# Service Bulletin #7

30 April 1992 - Rev C

- VFX VERSION 2 UPGRADE

#### **PART 4            INSTALLING THE ENCLOSED ESP CHIP AND                          SETTING THE ESP POT**

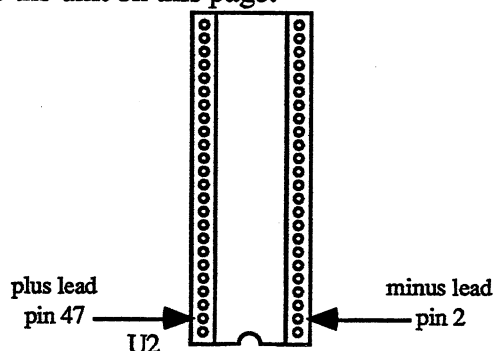
1. Be sure that the tower board has the correct values required for the Rev 2 ESP chip (see Part 3 above).
2. Carefully remove the Rev 1 ESP chip from the U2 socket on the tower board.
3. Be sure that there are no audio cables plugged into the VFX. Center the ESP pot.
4. Leave the keyboard disconnected and no chip in socket U2 (on the tower).
5. Set the volume slider to the lowest level.
6. Turn the VFX on. The wakeup screen will appear and then you will see the following message:

7. Set a Digital Volt Meter (DVM) to measure DC Volts. Facing front of the board, place the minus lead onto pin 2 of the U2 socket. Place the plus lead (red) onto pin 47 of the U2 socket.

8. Adjust the pot to the voltage marked on a label on the chip.

- 
9. Turn the unit off. Carefully install the enclosed ESP chip into the U2 socket on the tower.
  10. Reinstall the keyboard (see Section C of the VFX Service Manual). Make sure that the striped side of the keyboard cable is on pin 1 of the J6 connector on the main board. Remember that if the keyboard cable is mis-pinned, fuses F3 and F4 will blow.
